Shift Shaft Seal – 225 & 250

MARINER AND MERCURY

1996 225, 225 EFI, 250 EFI

Figure 1. Shift Shaft Bushing Assembly

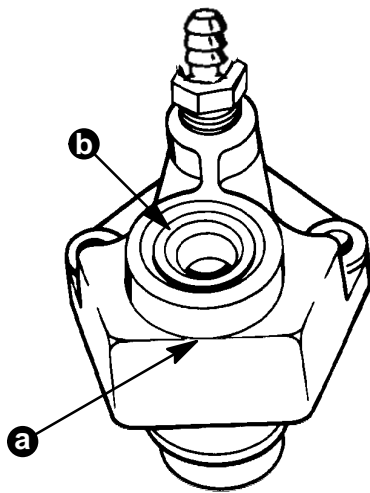
The shift shaft oil seal on the models listed may become loose and allow water to enter the gearcase. On a small quantity of units, the shift shaft oil seal hole in the bushing was machined 0.002 inch (0.05 mm) too large.

When servicing any of the product listed, check if the powerhead has the identification mark and, if not, replace the shift shaft bushing and mark the powerhead.

IMPORTANT: DO NOT install p/n 23-815921A 8 shift shaft bushing into an outboard gearcase.

When replacing a shift shaft bushing on 225, 250, and 3 Litre Marathon/Sea Pro models, install p/n 23-815921A 4. The A 4 has a p/n 23-816464 1 shift shaft seal that will release excess pressure. The parts manual will be changed at the next reprint.

Figure 2. Port Side View

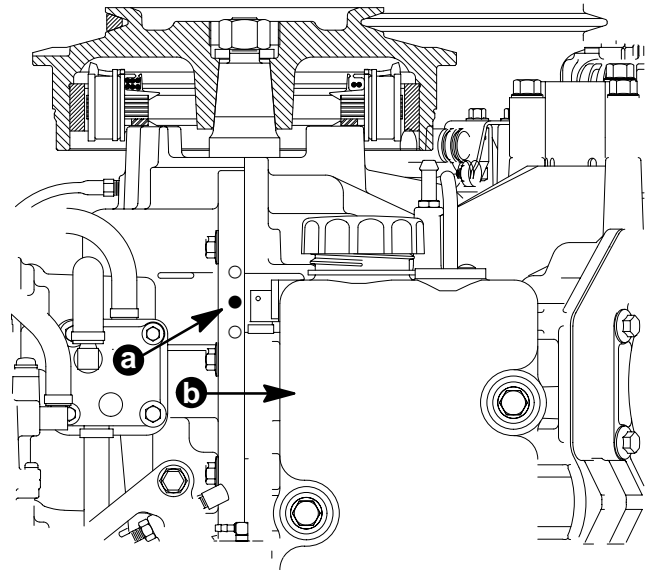
a white paint dot on the port side of the powerhead by the crankcase split line forward of the top of the oil tank.

Paint a white paint dot on the port side of the powerhead by the crankcase split line forward of the top of the oil tank (refer to Figure 2).
